AGENDA
TOWN OF RICO BOARD OF TRUSTEES
2 Commercial Street– Rico Town Hall
November 16th, 2022
7:00 PM

During the last month's planning meeting the commission continued the hearing of the Dolores River Trail subdivision to allow for a site walk and additional time for Mountain Civil Engineering to provide a response to comments submitted by the National Forest and Town of Rico's contract engineer, Alpine Land Consulting. A site walk was conducted on October 26, 2022. Mountain Civil Engineering submitted

revised plans and a memo addressing the comments provided by the Nation Forest and Alpine Land Consulting on November 2, 2022. The planning commission conducted a public hearing on November 9, 2022 and recommended approval of the preliminary plat with conditions. The draft minutes are included in the packet.

Revisions:	
#	DESCRIPTION

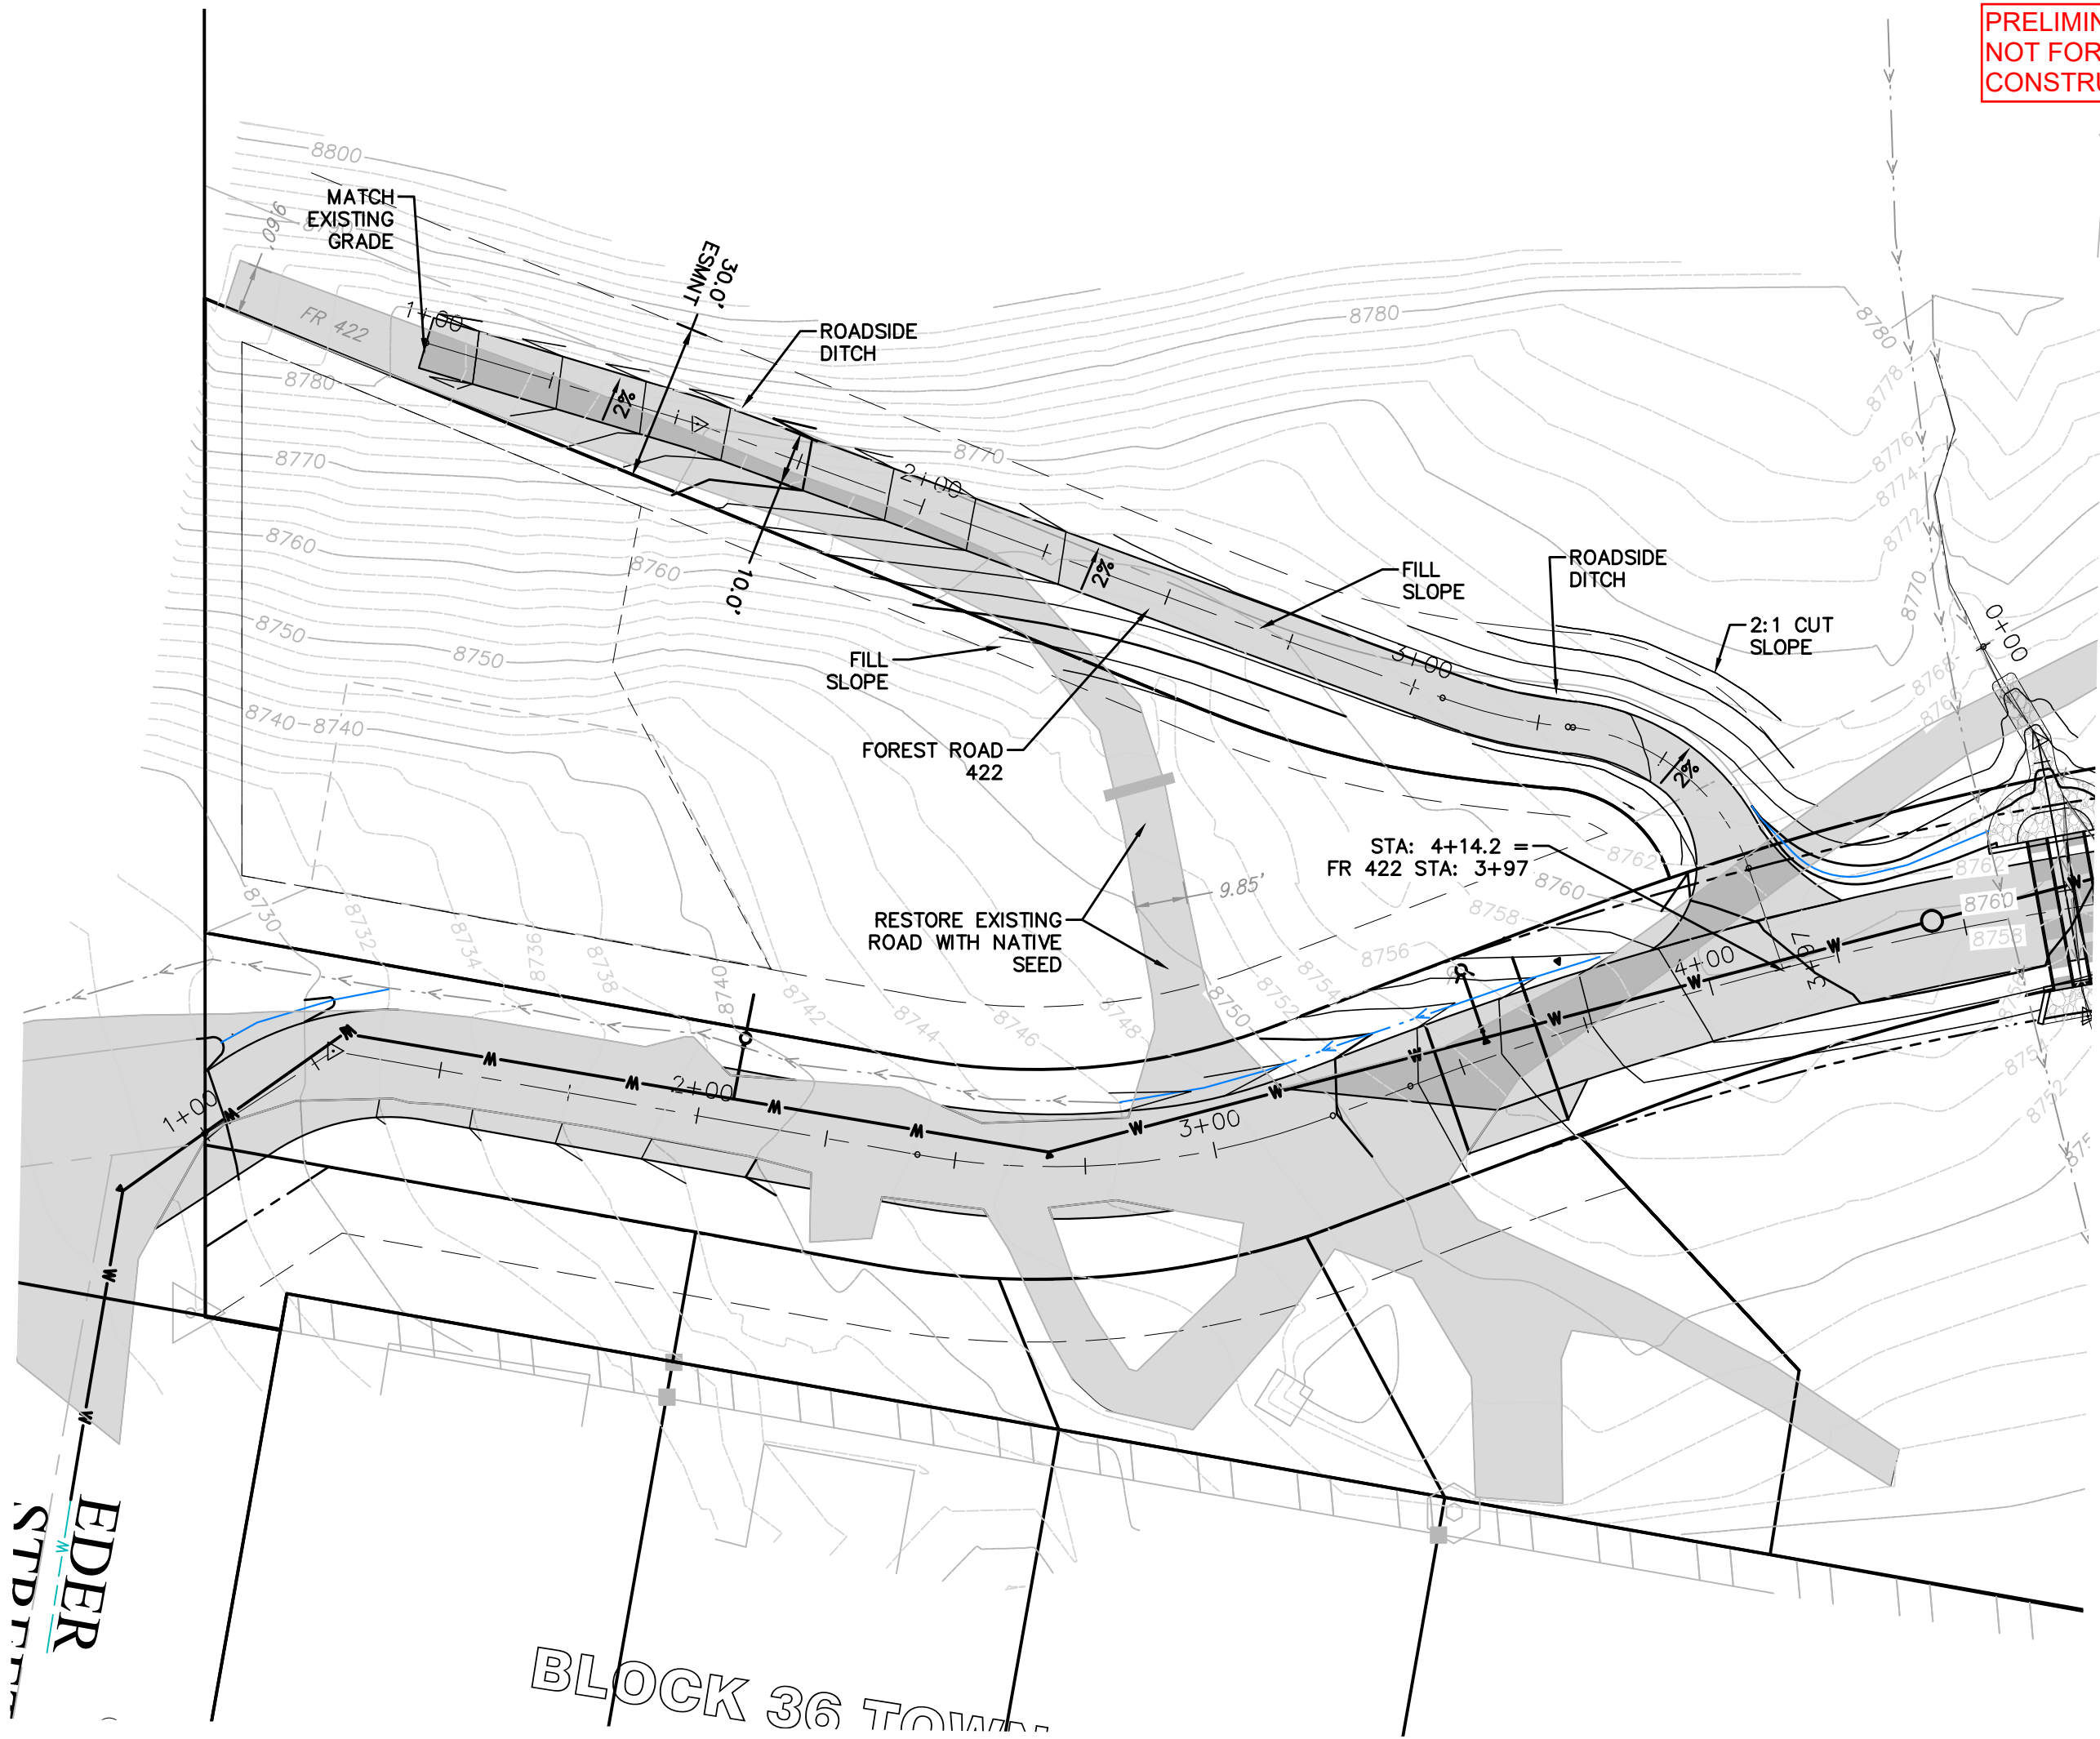
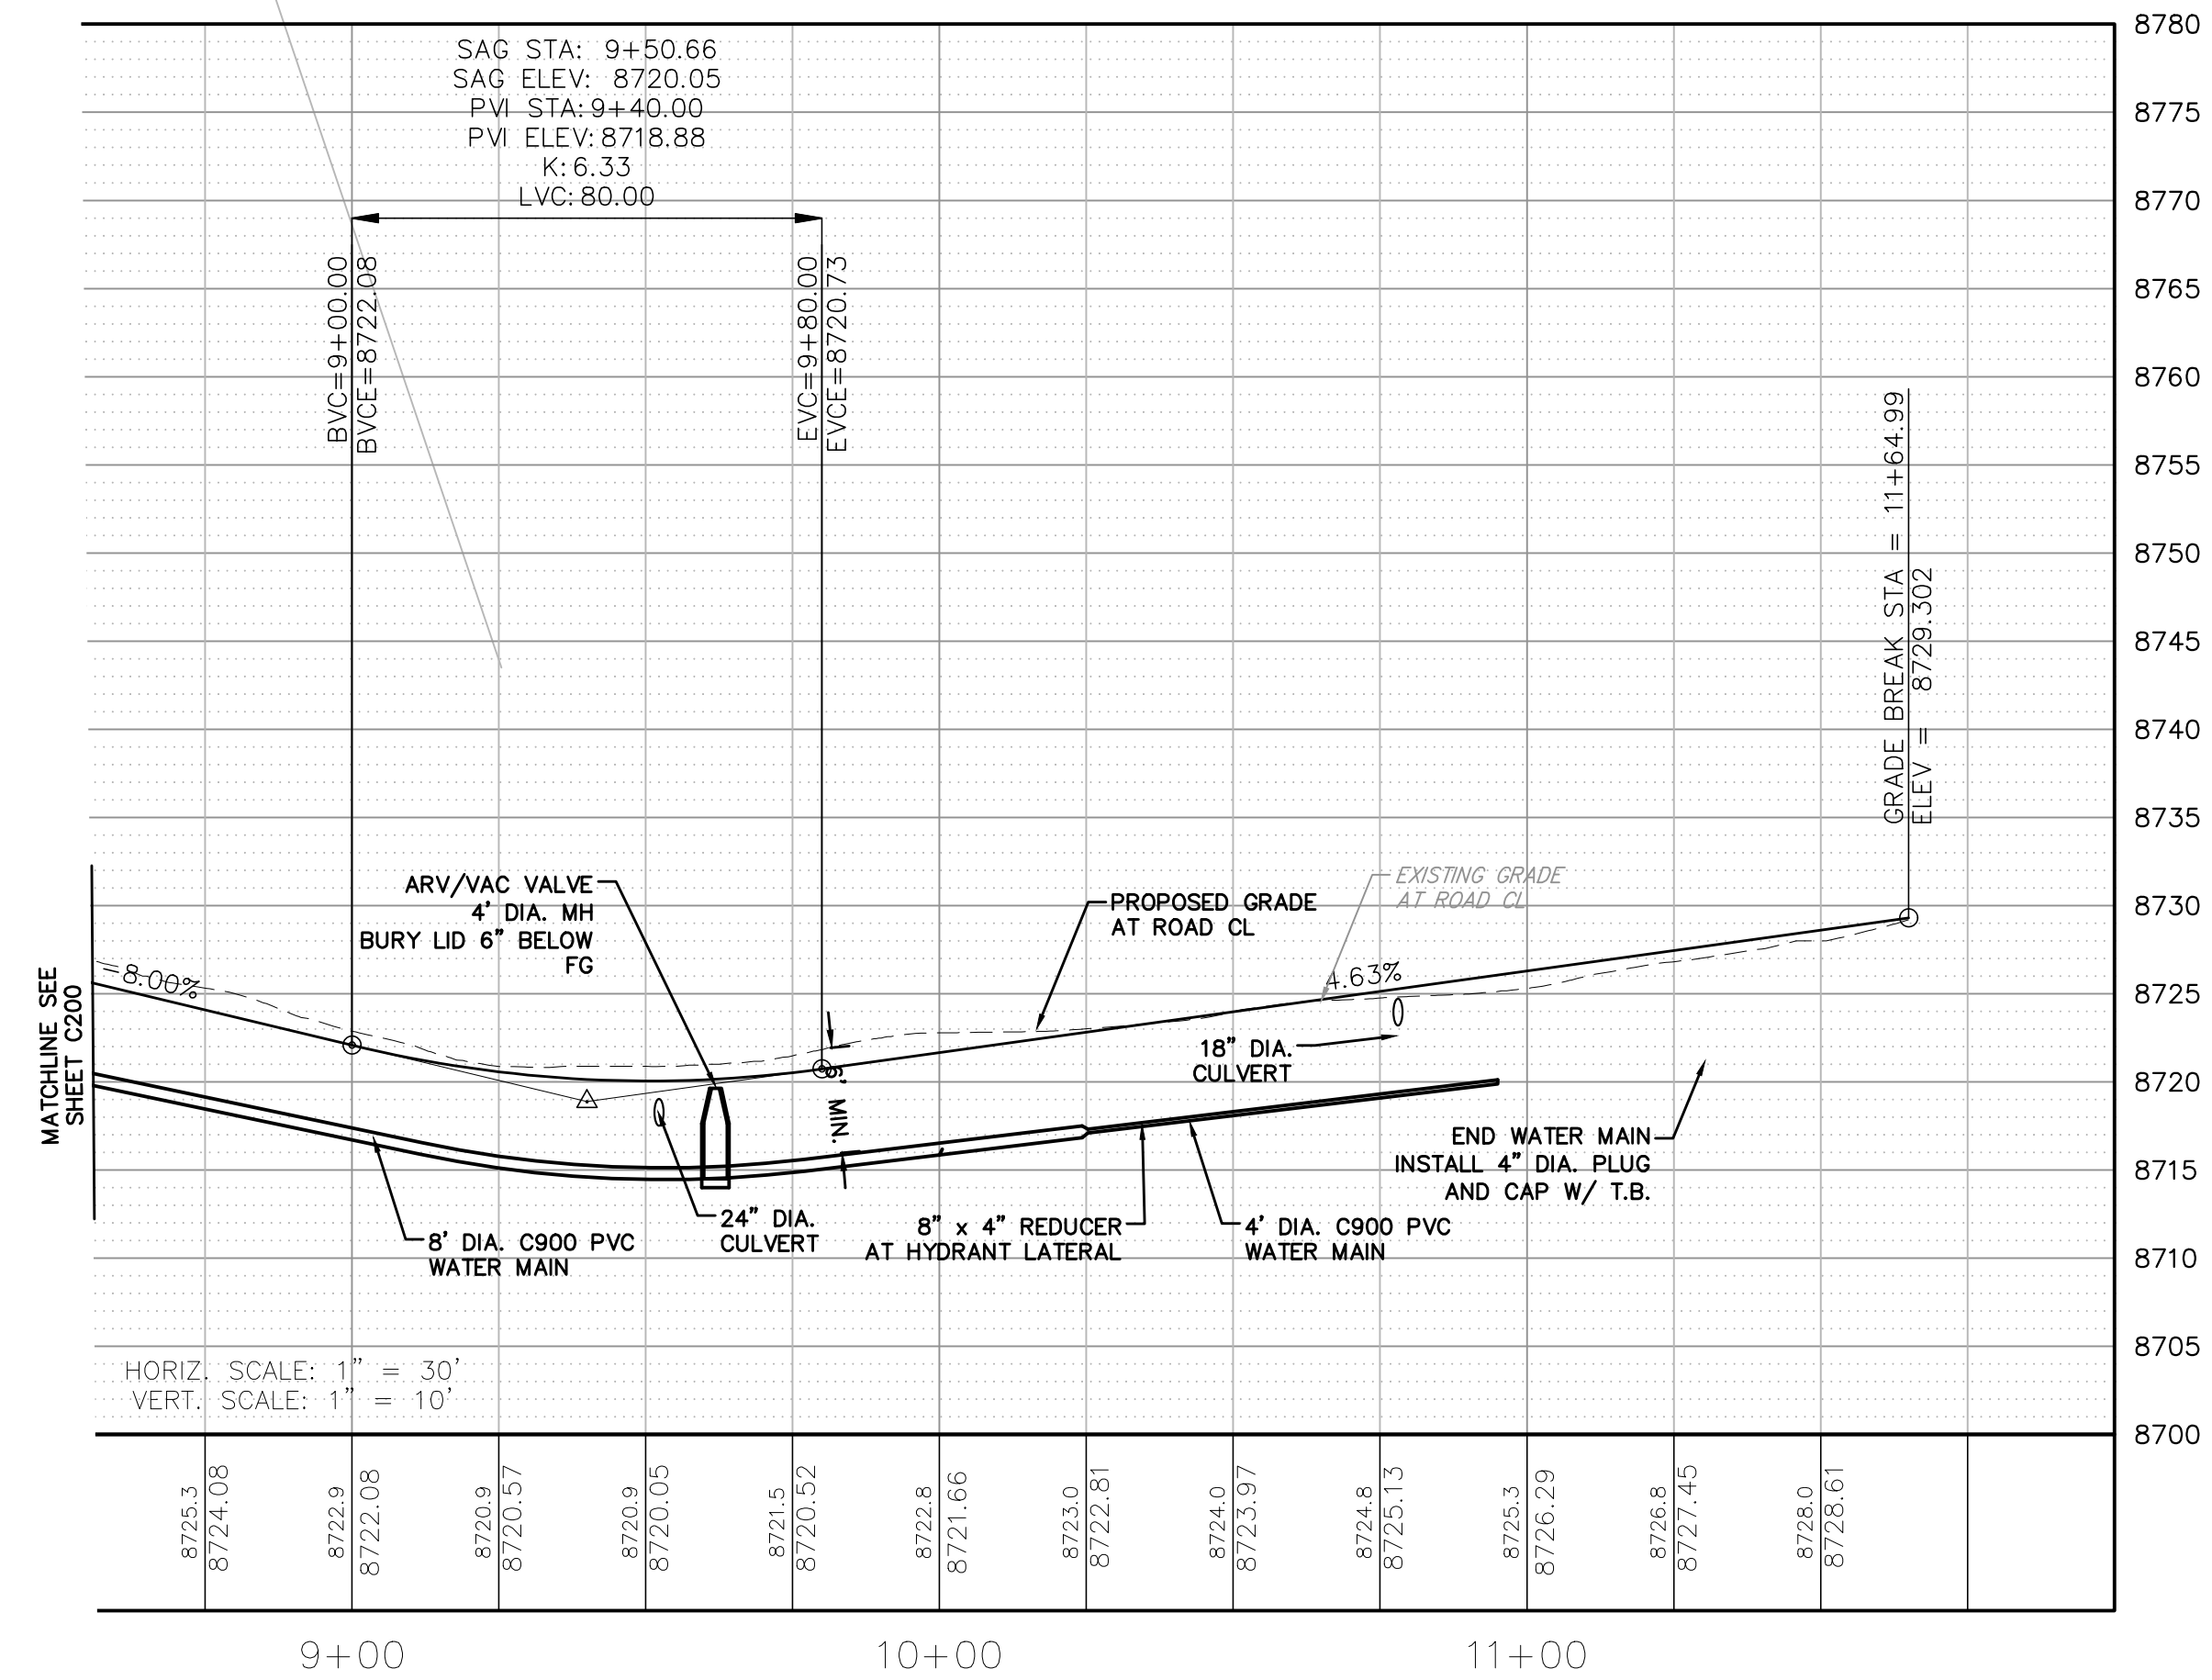
Sheet 5: It appears that the intent is to out slope the new alignment of 422 (indicated by the arrow and 2%). This seems like a risk given the new finished grade of 12% from station 1+00 to approximately 2+00. In addition, I believe the existing road beyond 1+00 continues at a steep grade. The risk I see is that the out slope will likely divert water off the newly constructed fill slope at the transition from 12% to 3% which appears to be approximately 7 feet of fill and on to the private property. The drawings do indicate a roadside ditch on the cut-slope side and it may be more appropriate to in-slope the road to this ditch. This would be the construction approach by the FS.

Sheet 5: The detail appears to indicate armored road side ditch from approximately 3+25 to 4+00 I am not clear on the intention of this design element but from a maintenance perspective the Forest Service would prefer to have the ditch remain native material.

6. Typical section for FR 422 has been added to sheet C400, including note on lift of fill material. All road work shall be constructed per Town of Rico or CDOT Standard Specifications for Road and Bridge Construction, including placing of embankment material.
